Merged Document Report

Application No.: PL8891

Document Filename
202579326 - STRIPES CORPUS - PLAT r2 12.2.25.pdf
C7.0 UTILITY PLAN.pdf
Application for Land Subdivision_signed.pdf

**PLAT OF
STRIPES CORPUS CHRISTI**

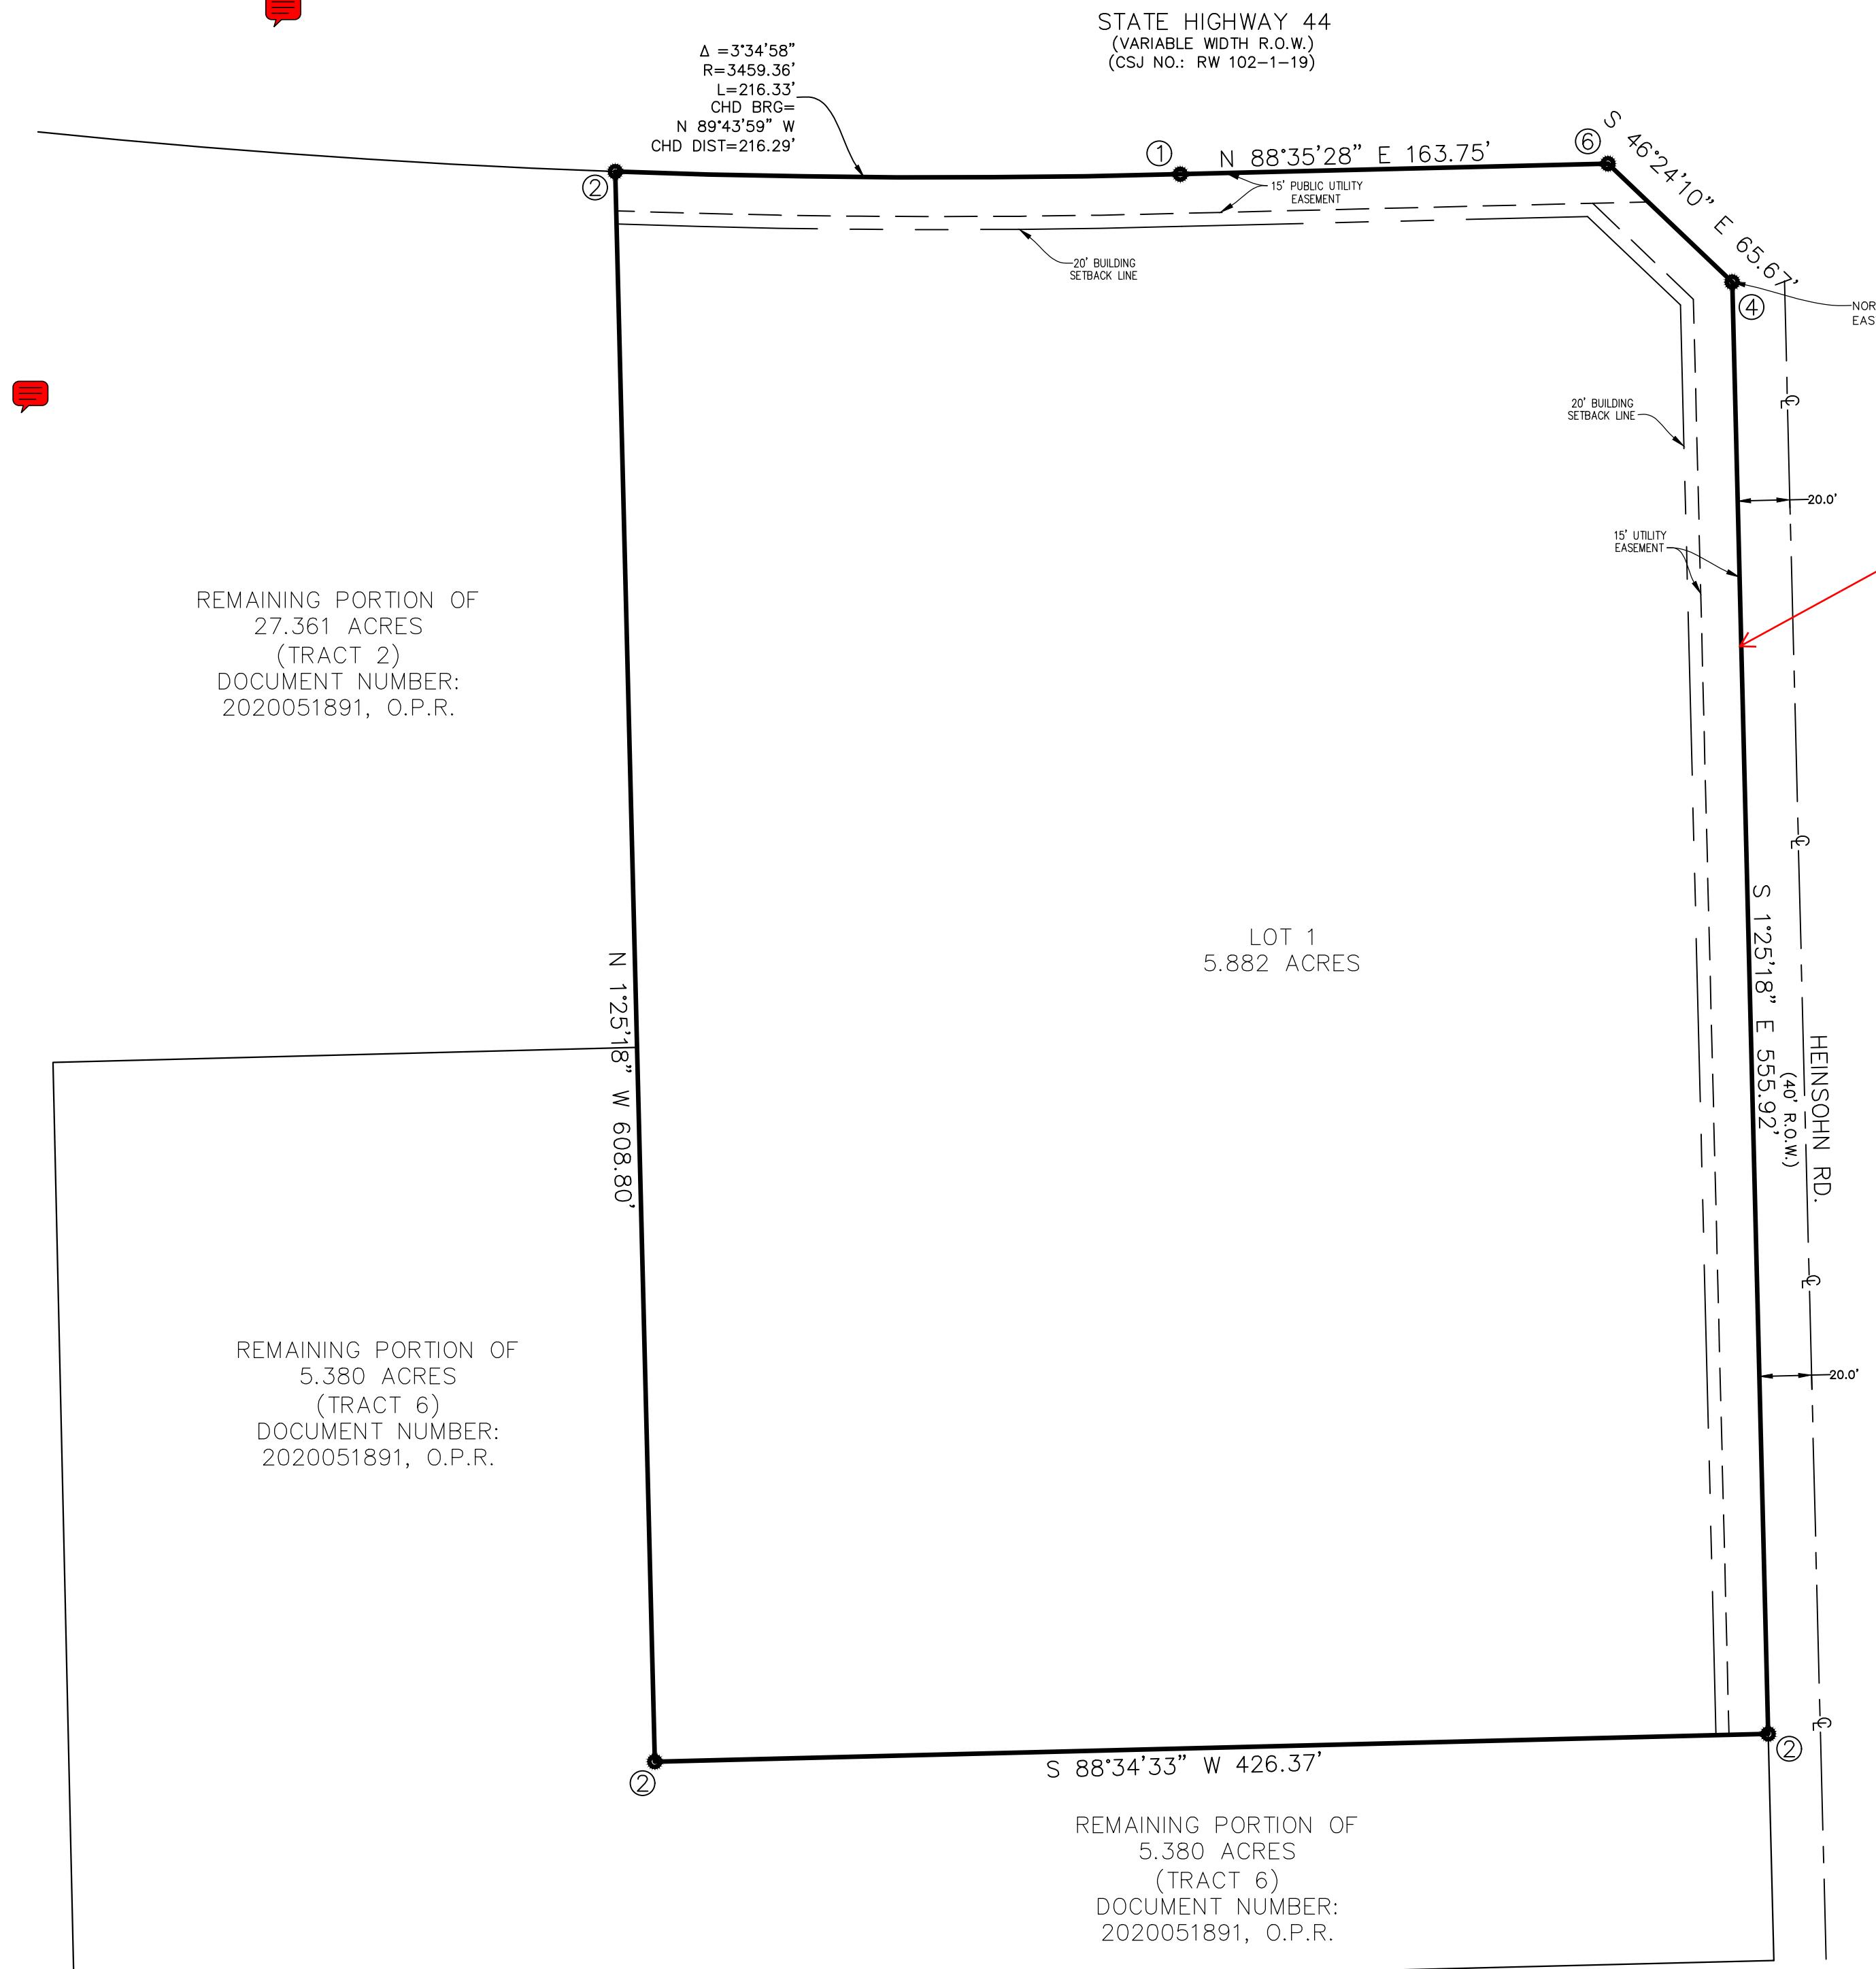
3	P001	Note	Mina Trinidad : DS	Closed	Storm Water Quality Management Plan (SWQMP) required to be submitted.	
4	P001	Note	Mina Trinidad : DS	Closed	<p>There appears to be a discrepancy between the property listed in the deed and referenced on the plat of "Lots 17 and 21."</p> <p>Please provide appropriate deed for properties being platted.</p>

10	P001	Note	Mina Trinidad : DS	Closed	Remove signature blocks as Plat is a Preliminary Plat. Preliminary plats go to Planning Commission but do not get recorded, therefore, signature blocks are not necessary.	
11	P001	Note	Mina Trinidad : DS	Closed	<p>(Informational) Traffic/ROW: The developer / applicant can reach out to ROWManagement@cctexas.com for further assistance regarding ROW Permit Questions. Any contractor working within City ROW without an approved ROW Construction Permit can be held in non-compliance and can be subject to a fee of \$1,500 per day of unpermitted work, as per City of Corpus Christi Municipal Code 49-112 (9). For further information, please email ROWManagement@cctexas.com.</p> <p>A contractor can be found in non-compliance while working on city ROW with a permit if they deviate from the proposed work and permit approved by ROW. A fee of \$1,500.00 per day as per City of Corpus Christi Municipal Code 49-112 (9) & Code Sec. 49 - 57- 1 (h) & Code Sec. 49 - 57 - 2. For further information, please email ROWManagement@cctexas.com.</p> <p>A person / contractor / applicant shall be held responsible for damage to and in public</p>

Comment ID	Page Reference	Annotation Type	Author : Department	Status	Review Comments	Applicant Response Comments
					Engineering issues a Letter of Authorization to the utility company, allowing for construction of the street lighting system, once this process is complete.	
13	P001	Note	Mina Trinidad : DS	Closed	(Informational) Parks and Recreation: No fees applicable as the plat describes the creation of a Stripes Convenience Store along with a Gas Station. As no newly proposed Residential dwelling unit(s) are to be created, no fees are to be applied.	
14	P001	Note	Mina Trinidad : DS	Closed	(Informational) Equistar Pipeline will not be involved and has no additional comments.	
15	P001	Note	Mina Trinidad : DS	Closed	(Informational) GIS: Plat of Stripes Corpus Christi closes within acceptable engineering standards.	
17	P001	Note	Mina Trinidad : DS	Closed	Increase site size on the location map to show surrounding street names.

18	P001	Note	Mina Trinidad : DS	Closed	Remove signature blocks as Plat is a Preliminary Plat. Preliminary plats go to Planning Commission but do not get recorded, therefore, signature blocks are not necessary.	
19	P001	Note	Mina Trinidad : DS	Closed	11/18/2025 Update: Increase text size for better visibility. General note needs to follow City of Corpus Plat Guidelines for the "Receiving Waters" general note. Add the Storm Water Receiving Waters general note on the plat.	
20	P001	Note	Mina Trinidad : DS	Closed	11/18/2025 Update: Increase text size for better visibility. On side of plat ensure owners name, engineer's information, and surveyor's information is provided.	
22	P001	Callout	Alex Harmon : DS	Closed	Place a 15' UE along Heinsohn Rd per UDC 8.2.3.A.	
32	P001	Note	Mina Trinidad : DS	Closed	(Informational) CCRTA: This plat is not located along any existing or foreseeably planned CCRTA service route.
